**ADDENDUM #02
TO INVITATION TO BID #01**

**OLD GREENWICH SCHOOL – ADDITIONS AND ALTERATIONS
STATE PROJECT NUMBER 057-0115 EA/RR/CV
285 SOUND BEACH AVE
OLD GREENWICH, CT
APRIL 17, 2025**

2. **SP+A Bulletin #2** - dated April 16, 2025.

LP501

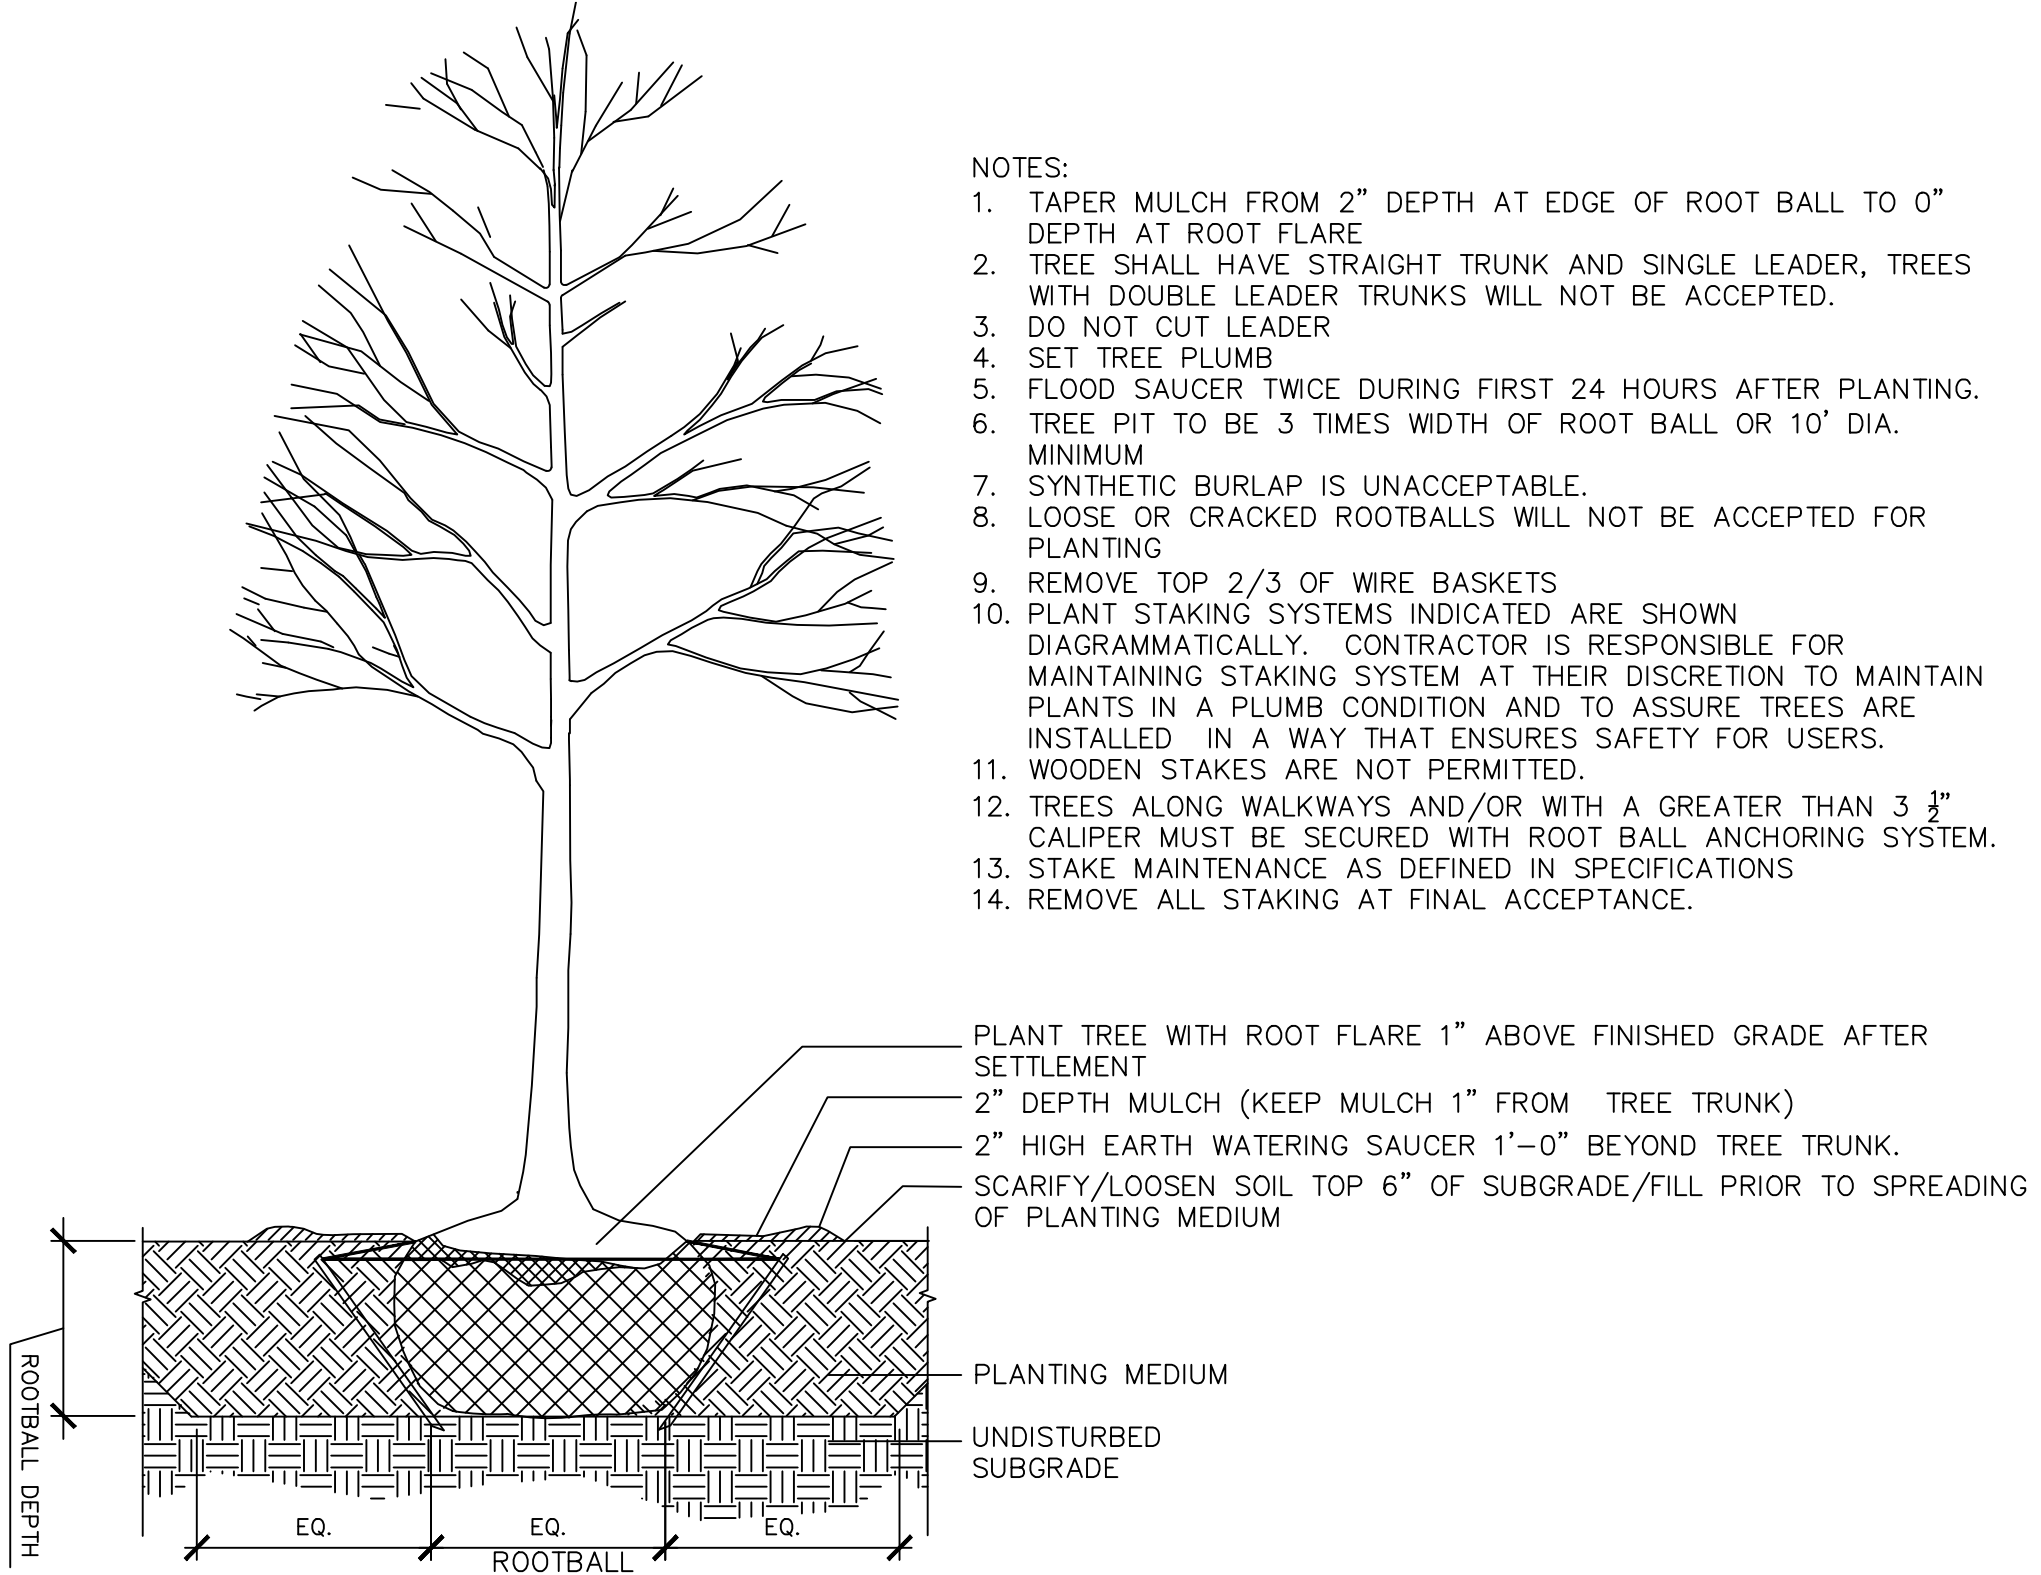
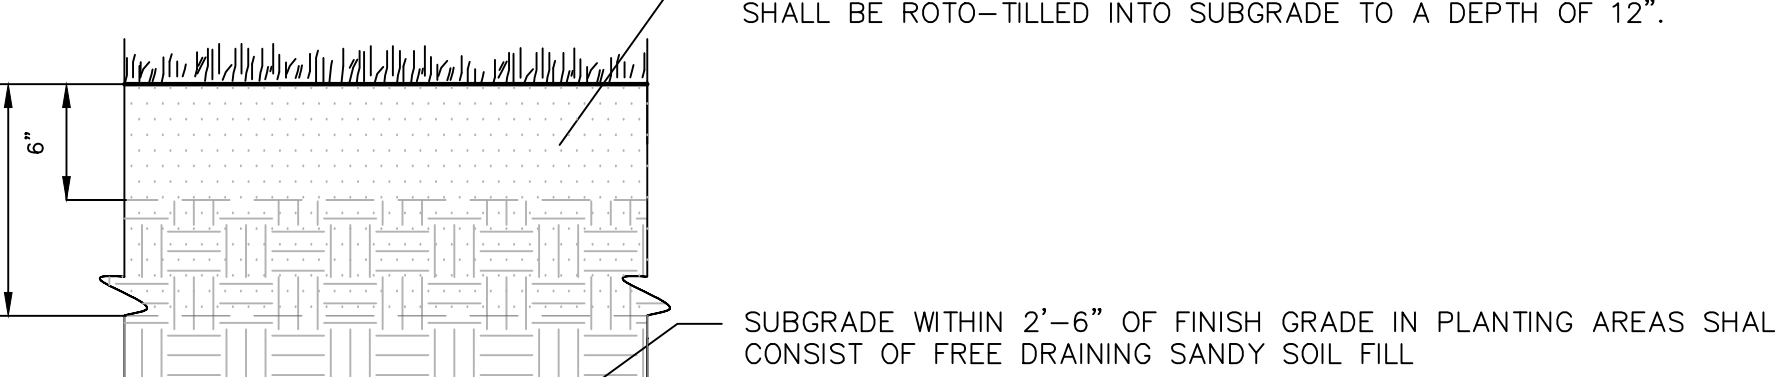
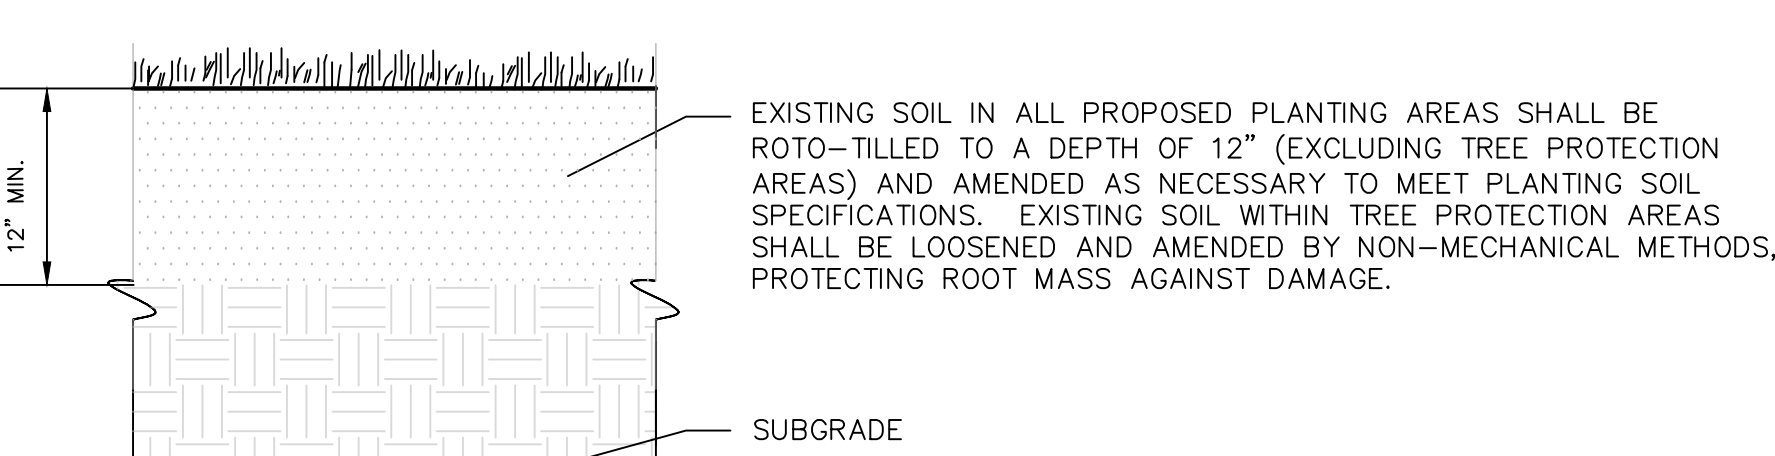
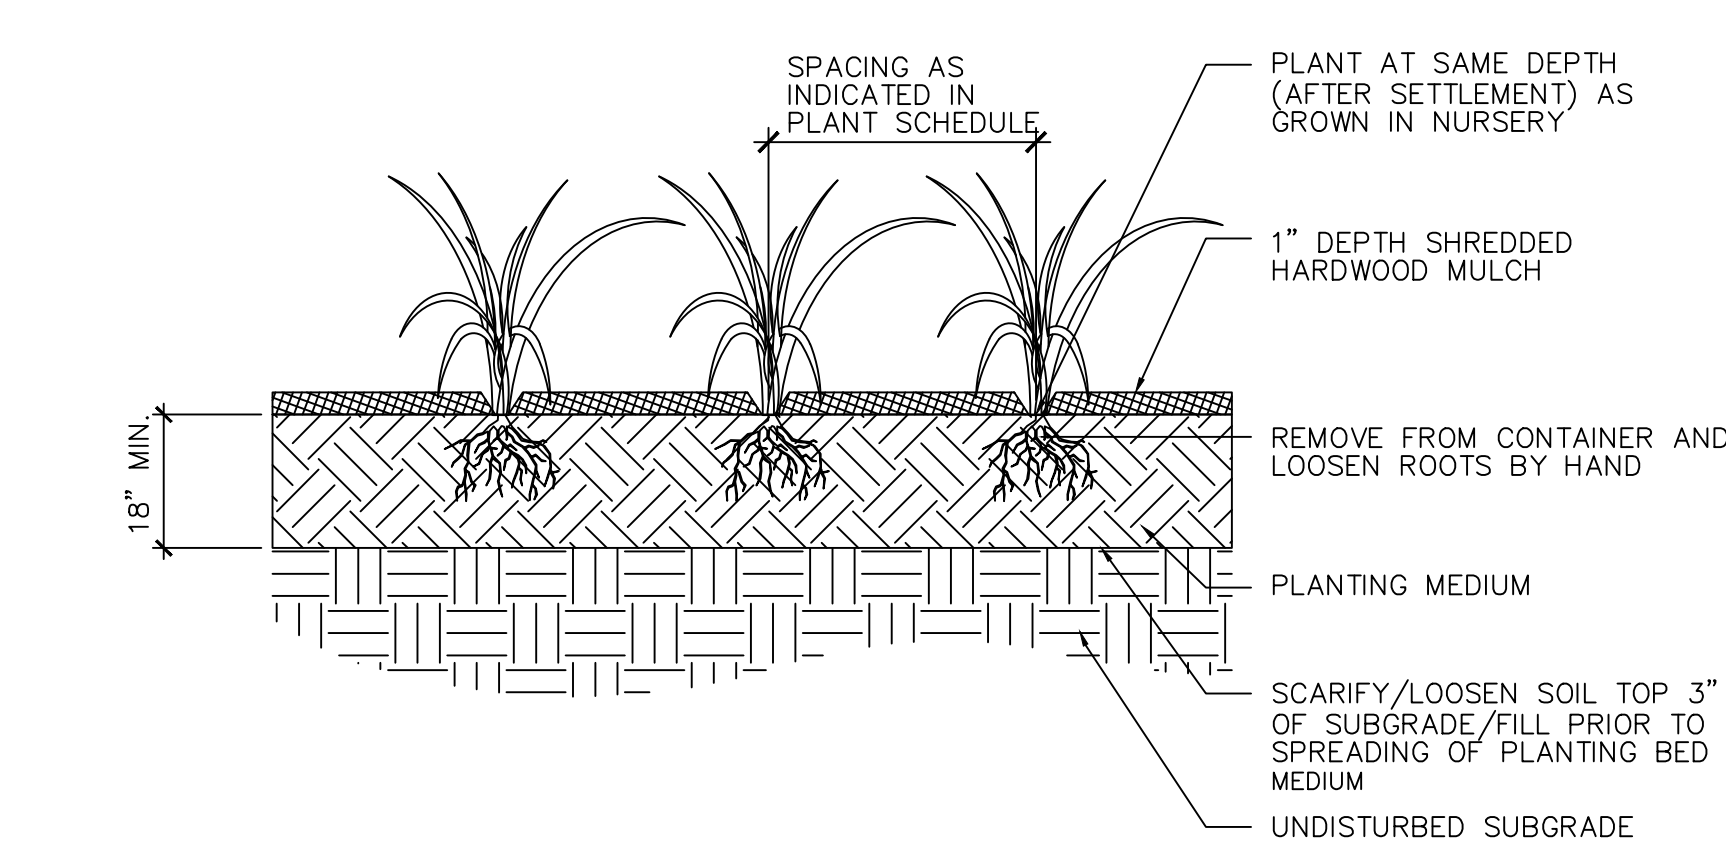
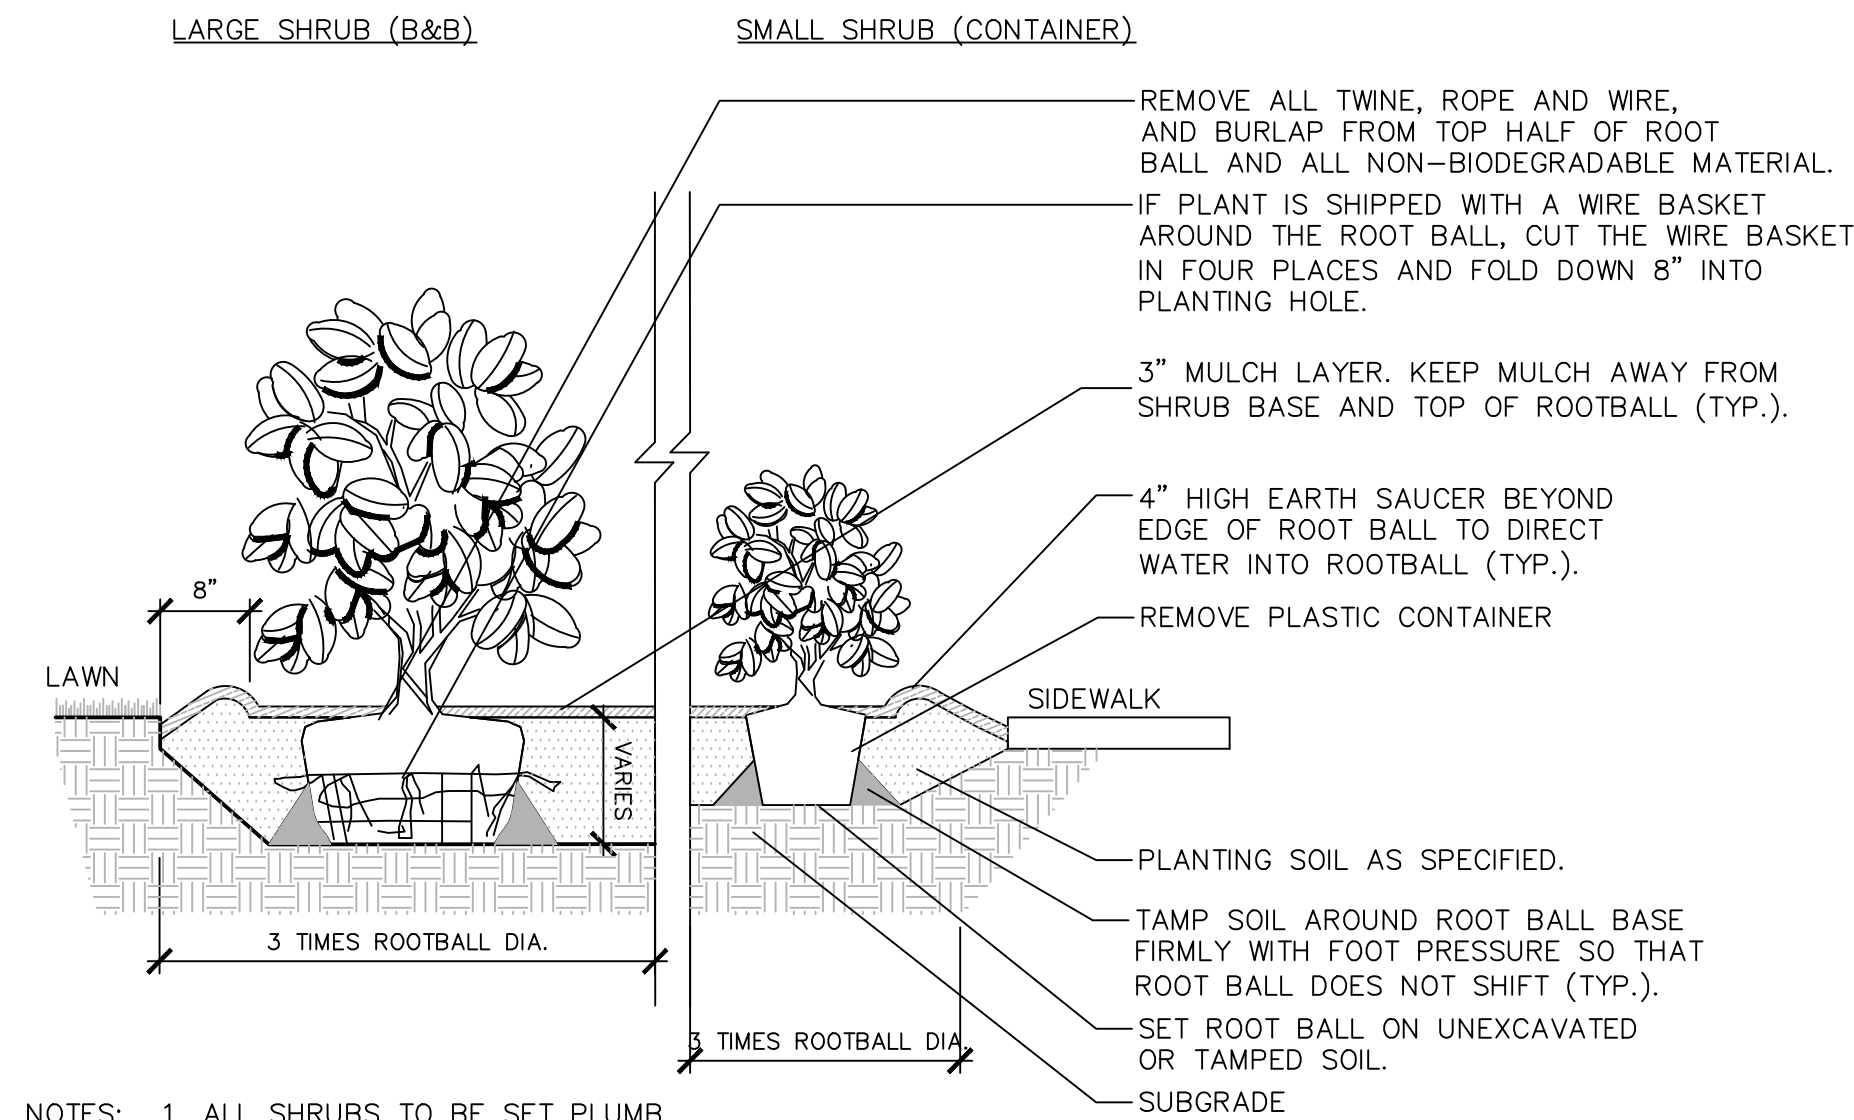
- **RFI #7** **Question:** Detail 5 on LP501 calls for Book Pavers to be installed within Dashed Lines in the Mulch. Are they to sit on mulch or subbase. What is the size of the Book Paver?

Response: Book paver to be set in mulch, no subbase required. Book pavers are provided by Owner. Refer to revised Drawing LP501 in Bulletin #2.
- **RFI #8** **Question:** Please confirm the stone mulch is within the CSK trees. The south planting bed lists the Red Twig Dogwoods as CSK, however, north list tress as CS. Please advise
